4 February 2022

Ref: L01/205550D/NB

NW Bicester – Response to Environment Agency Comments

Figure 1 – Comparison of the 0.1% Event with 25% Topsoil and Surface Water Flood Extent

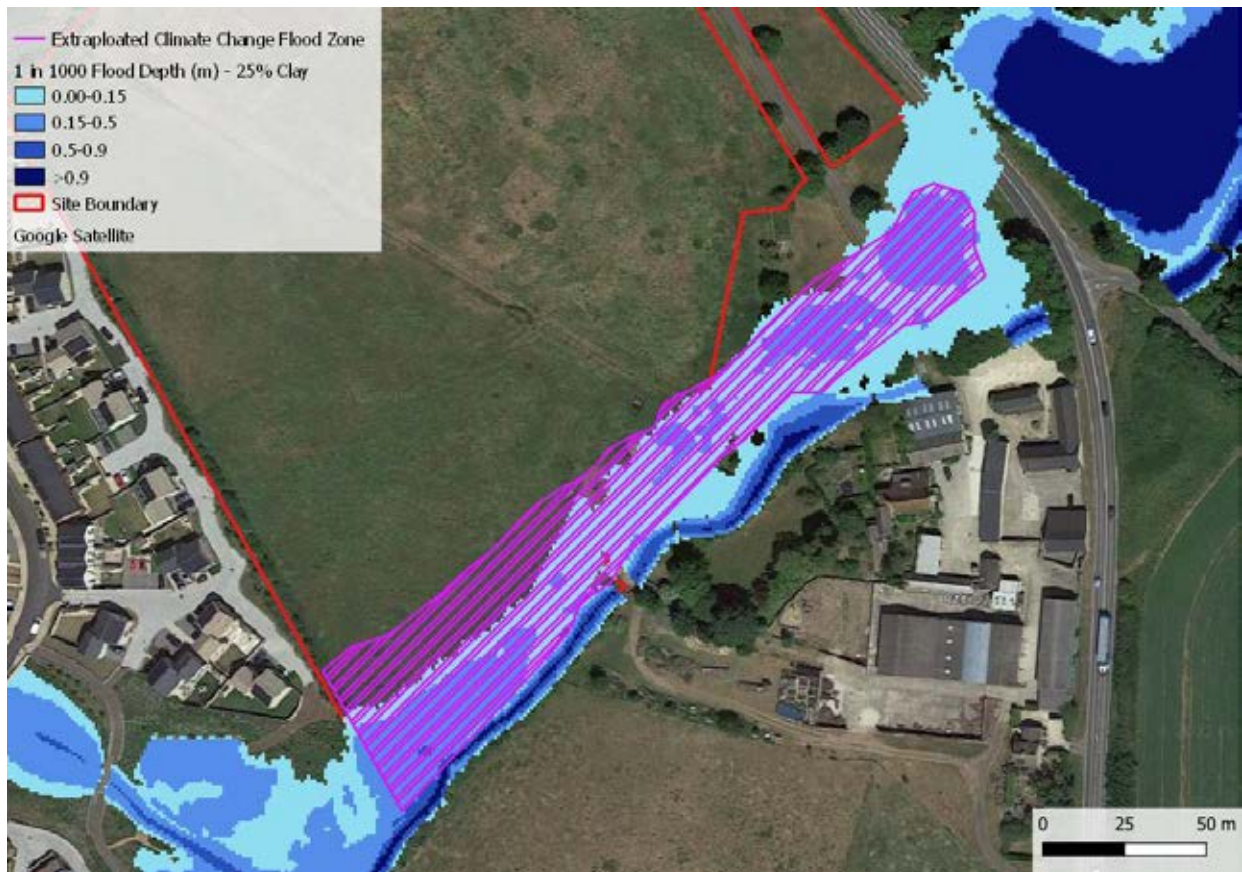
The very conservative sensitivity test outlined above has not changed this conclusion. The resultant flood extent associated with a theoretical 25% clay topsoil coverage is still smaller than that defined by the two data sources identified above. This is shown in Figure 1 and 2.

Whilst it is accepted that the findings of the ground investigation for the site has introduced a little uncertainty with respect to the hydrological calculations, this has no bearing on the conclusions or purpose of this study. There is no desire to update the Flood Map for Planning and it has been shown that the masterplan is robust and any potential uncertainty will not introduce developed parts of the site into the floodplain.

Appendix B – Revised Flood Maps – Sensitivity Testing

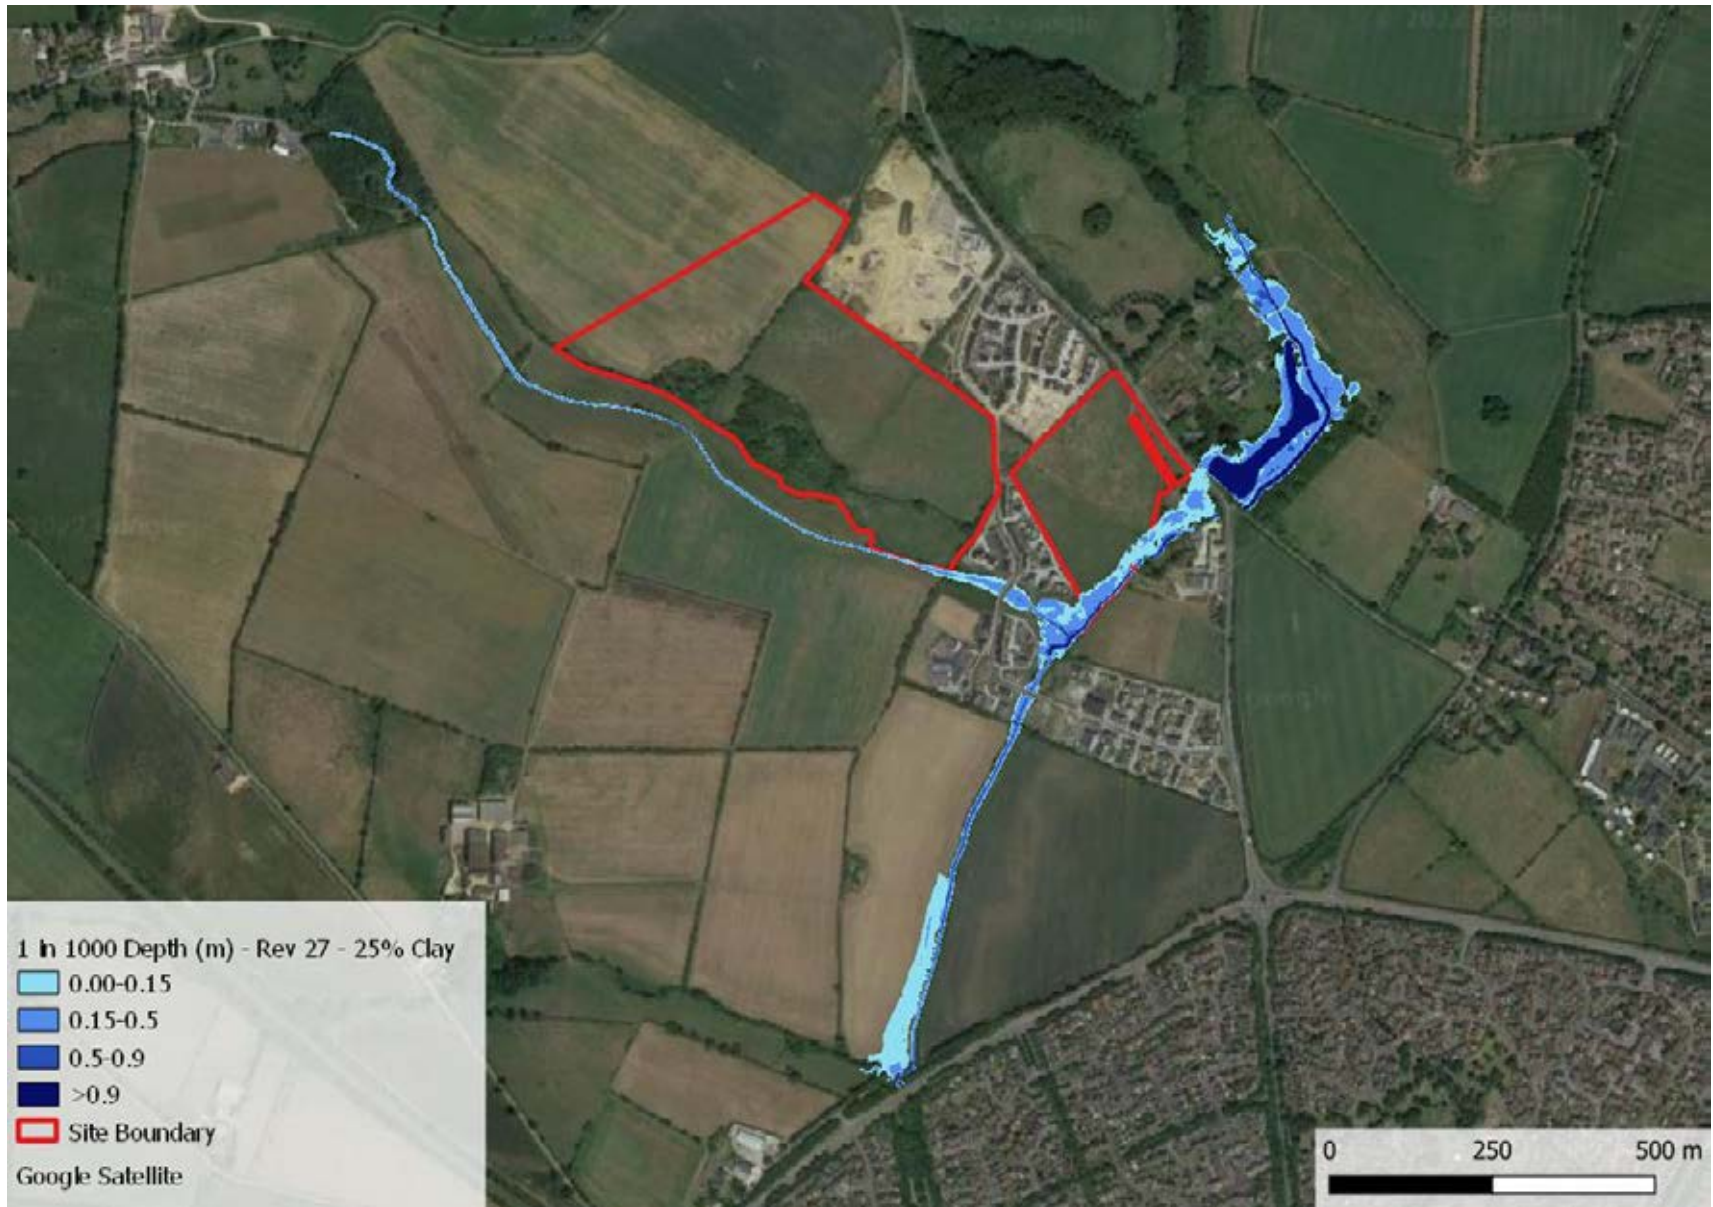
To test the impact of this potential uncertainty and demonstrate the robust nature of the model and parameters applied to the masterplan for the site, we have re-run the 0.1% annual probability event with both a 10% and 25% allowance of clay topsoil.

Whilst it was discovered that the flood extents for the 0.1% annual probability event have increased, this was not significant on site. The resultant flood maps are enclosed in Appendix B.
